2708 PRINCE STREET PROJECT – ZAB PACKAGE - RIEMER

2708 PRINCE STREET PROJECT – ZAB PACKAGE – RIEMER EXHIBITS TABLE OF CONTENTS

Re: 2708 Prince Street, Under the Circumstances of this Application the Finding of Non-Detriment Cannot Be Made; Request Denial or Design Modification.

RE: 2708 Prince Street Application, 12 September, 2024

2. **Obstruction of Sunlight, Air**
EASTERN VIEW (PRESENT) 5:00 P.M.

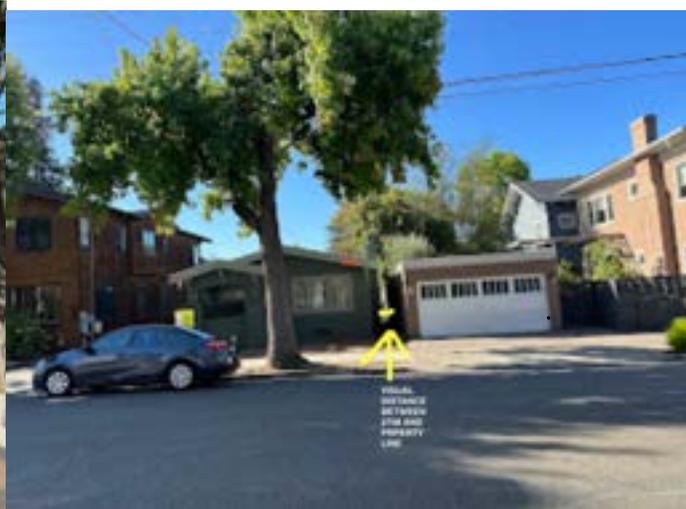
OBSTRUCTION OF SUNLIGHT, AIR AND LIGHT. PRESENT AND AS PLANNED

- **TOP: VIEW LOOKING DUE EAST FROM 2D FLOOR. Uninterrupted structure with no light pass**
- **MIDDLE: VIEW LOOKING SE FROM 2D FLOOR. Uninterrupted structure with minimal light**
- **BOTTOM: VIEW FROM YARD LOOKING DUE EAST**

**4. 1st FLOOR VIEW FACING EAST IN A.M
BEFORE**

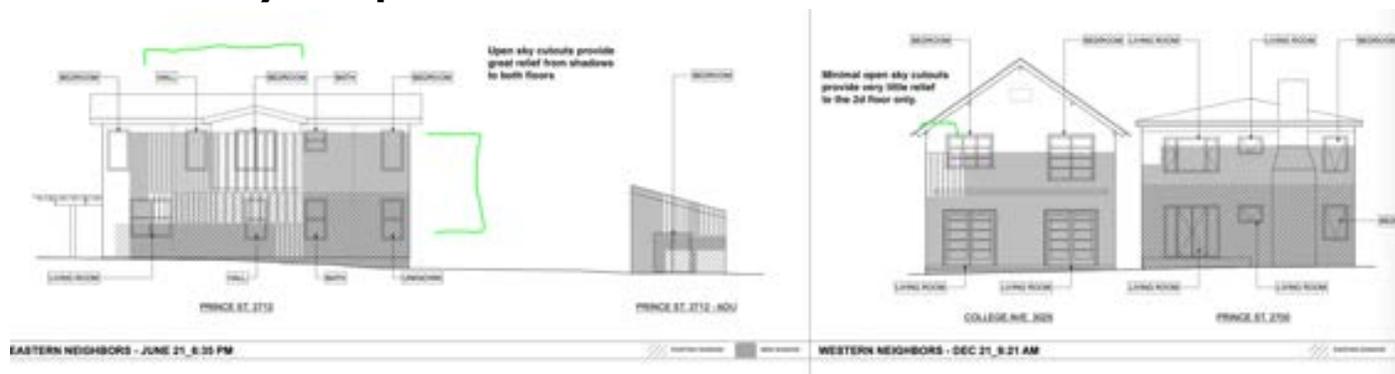
With a more conventional design there would be some breaks in the structure to allow air and light so pass through to us. We face a high oppressive solid wall from both the front and side, directly facing the project. Our morning sun is unnecessarily obliterated, and we drink our morning coffee in the dark or in artificial light.

2701 Prince2708

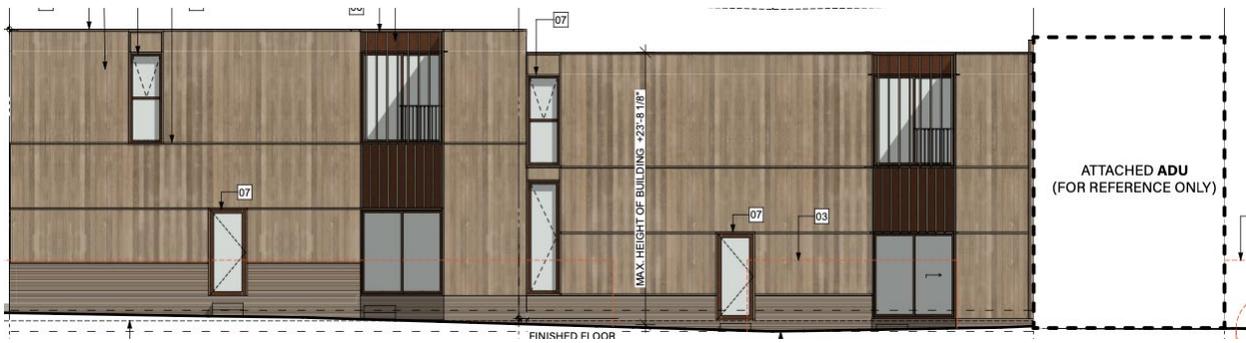
The Claremont Elmwood Neighborhood Association (CENA) respectfully requests that the Berkeley Zoning Adjustments Board (ZAB) to deny the application for 2708 Prince Street, or alternatively, to require design modifications that would preserve the historic look and feel of Prince Street.
